<b>City of Rocky Mount Addendum 1</b>		
	<b>Refer <u>ALL</u> Inquiries regarding this RFP to:</b> Chynice Chapman Purchasing Manager	<b>RFLOI # 320-050222CC Pedestrian Signals EB-5711</b>	
		<b>RFLOI Due Date: 03/25/2022</b>	
	<b>Contract Type: A&amp;E</b>

RFLOI PED SIGNALS  
EB-5711  
CITY OF ROCKY MOUNT  
NASH COUNTY NORTH CAROLINA

SHEET TITLE:  
VISUAL FOR  
RFLOI

#5 FRANKLIN ST & SUNSET AVE

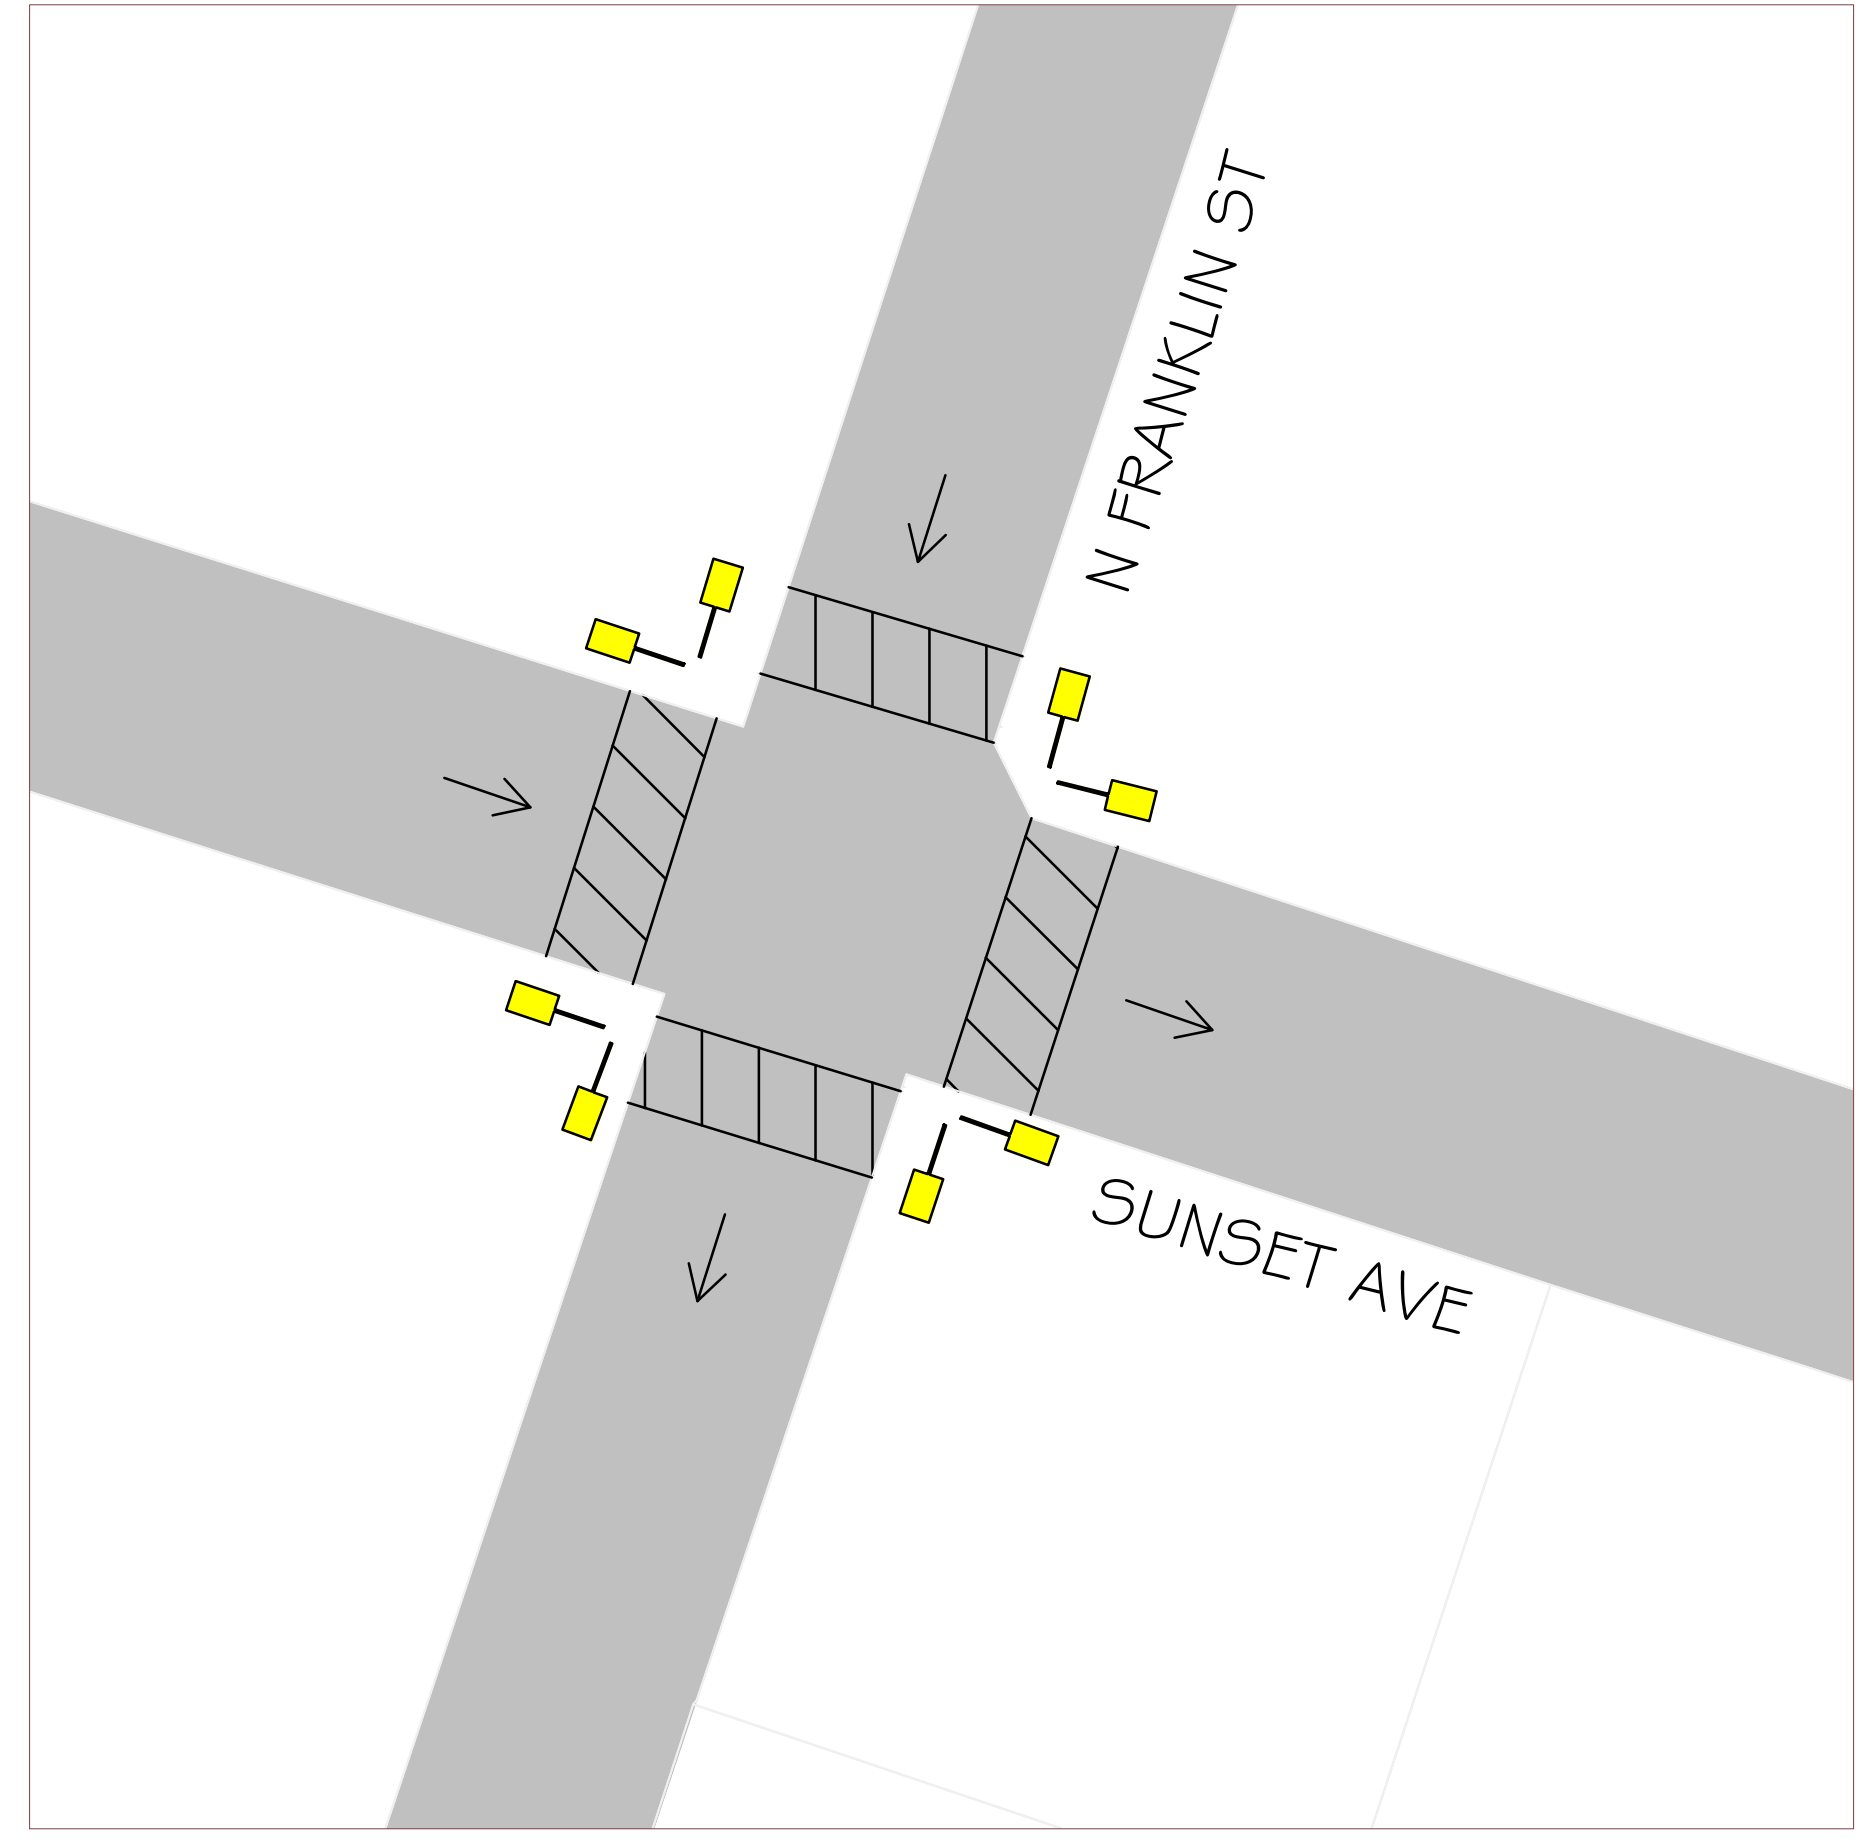
2. **Question:** Are only existing crosswalks to be signalized or does the city anticipate adding new crosswalks to be signalized as part of this project?

Lee street and Pine Street only require one cross walk and pedestrian signal over Sunset Avenue. May Drive, Grace Street, and Franklin Street require crosswalks and pedestrian signals at all four legs of the intersections. See attached sketch for more details.

1. MAY DR: 4 CROSSWALKS, 4 PED SIGNAL PAIRS
2. LEE ST: 1 CROSSWALK, 1 PED SIGNAL PAIR
3. PINE ST: 1 CROSSWALK, 1 PED SIGNAL PAIR
4. GRACE ST: 4 CROSSWALKS, 4 PED SIGNAL PAIRS
5. FRANKLIN ST: 4 CROSSWALKS, 4 PED SIGNAL PAIRS
